REVISIONS					
REV.	ECN NO.	LOCATION	DESCRIPTION	DATE	DESIGN
A1	N/A		图面升级整理图面	2025.06.04	阿树
A2	ECN-P-2026031201	Ⓐ2 X4	产品材质, 电气性能及尺寸变更	2026.03.12	阿树

DESIGN	阿树	VIEW:	MODEL TYPE:
CHECKED		UNIT: mm/in	TACT SWITCH
APPROVED		SIZE: A4	PART NO.: TS-1158B-B-A-BL
			DWG NO.:

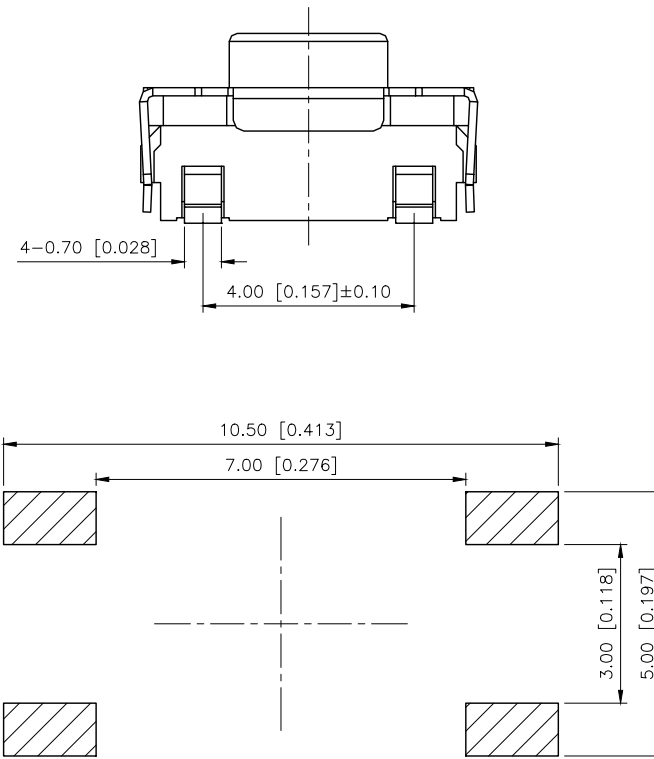
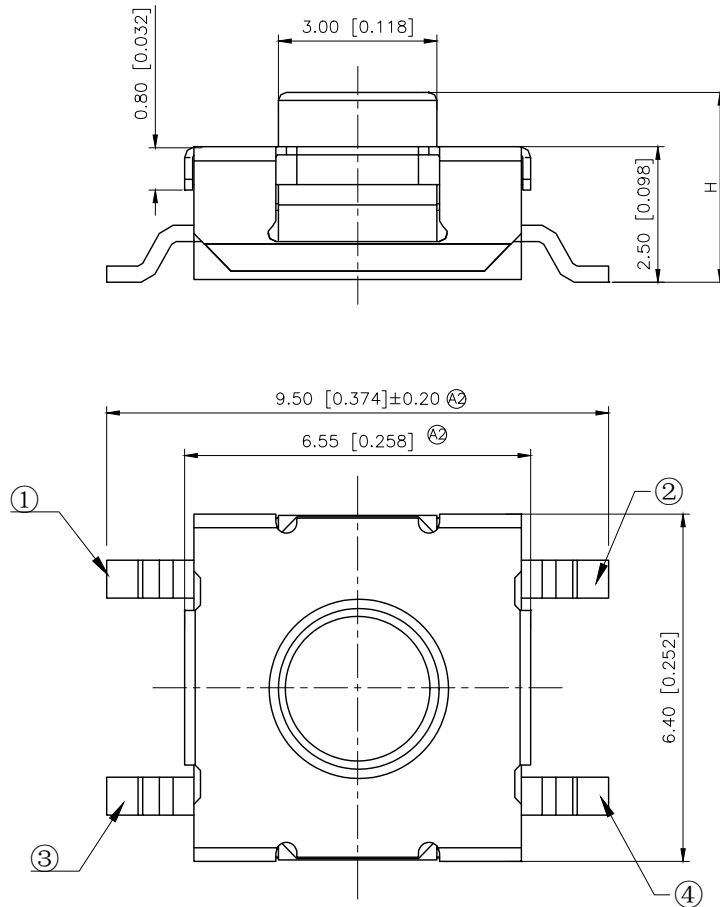
SPECIFICATION
Contact Rating: 50mA,12V DC
Contact Resistance: 100mΩ max
Insulation Resistance: 100MΩ min.500V DC
Dielectric Strength: 250V AC/1minute
Travel: 0.40±0.20mm Ⓐ2
Operating force:±50gf
Operating Temp: -40℃~+85℃ Ⓐ2
Storage Temp -40℃~+85℃ Ⓐ2
